SEVERANCE CORNERS PLAN  
SIGNAL ALTERNATIVE: IMPROVEMENT OPTION 2

<b>R S G</b> INC. <small>RESOURCE SYSTEMS GROUP, INC.</small>	SCALE: AS NOTED	SHEET
	DESIGNED BY: J. SLASON	1
	DRAWN BY: J. SLASON	
	CHECKED BY:	
	DATE: 5/17/07	
PROJ. NO.: 07067	OF 2

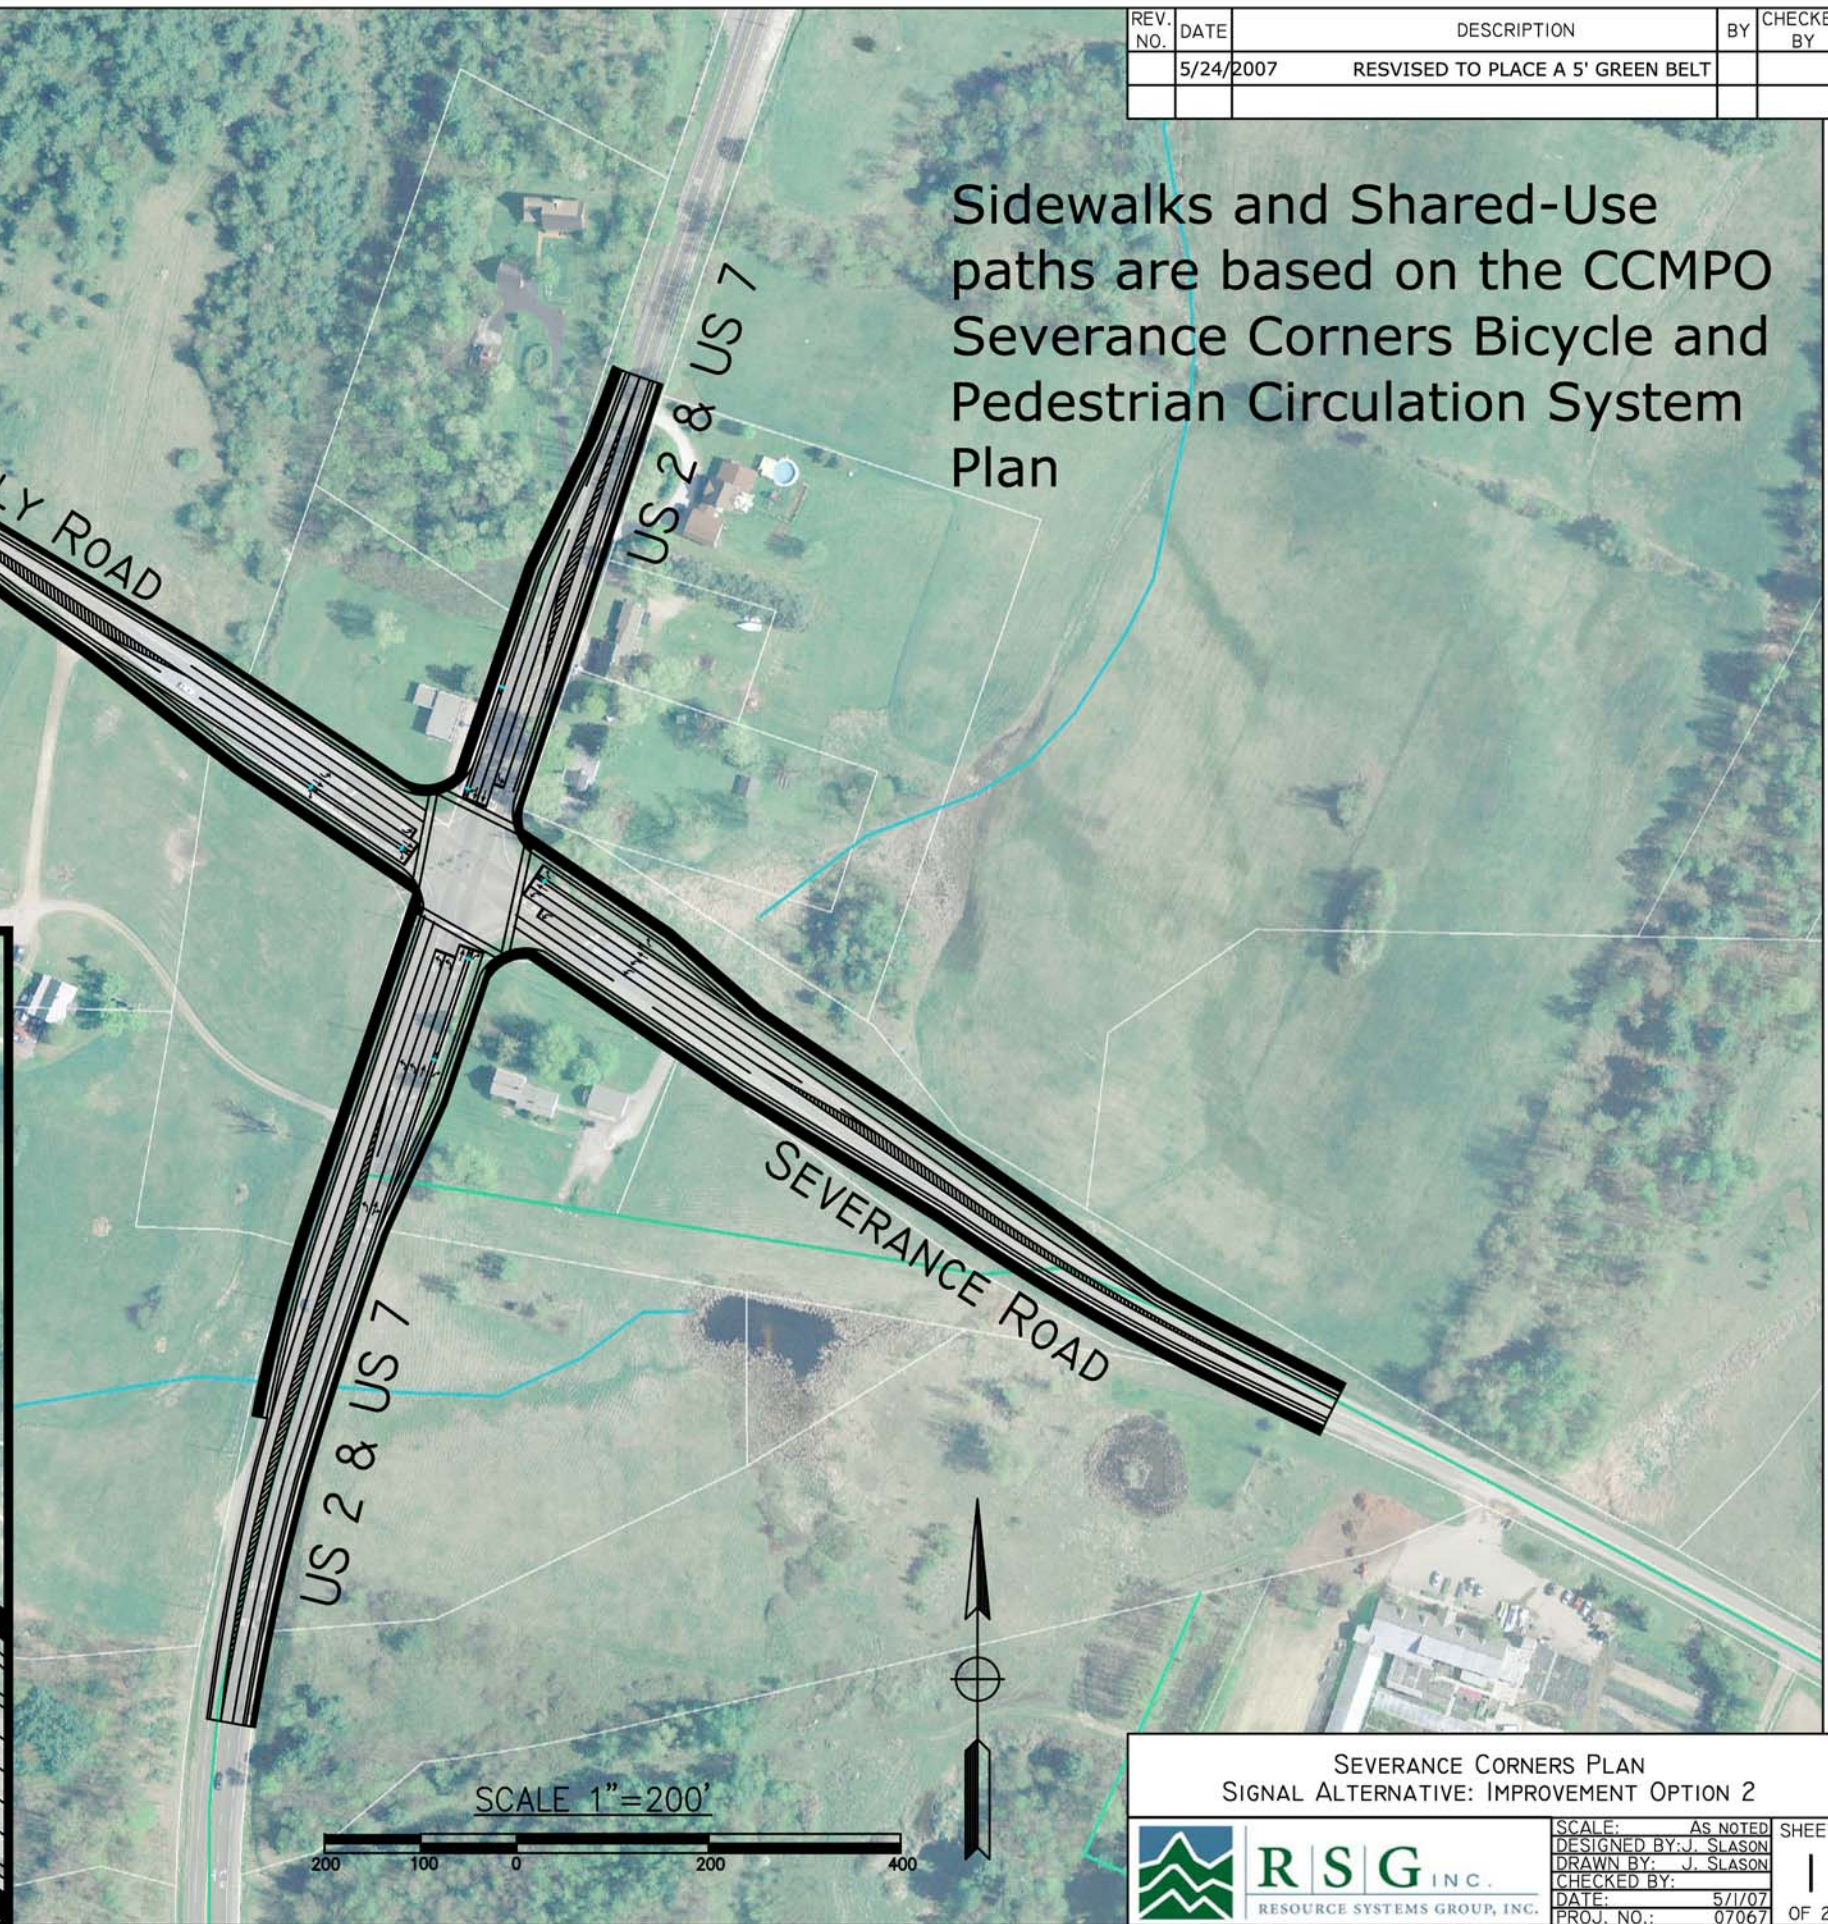
REV. NO.	DATE	DESCRIPTION	BY	CHECKED BY
	5/24/2007	REVISED TO PLACE A 5' GREEN BELT
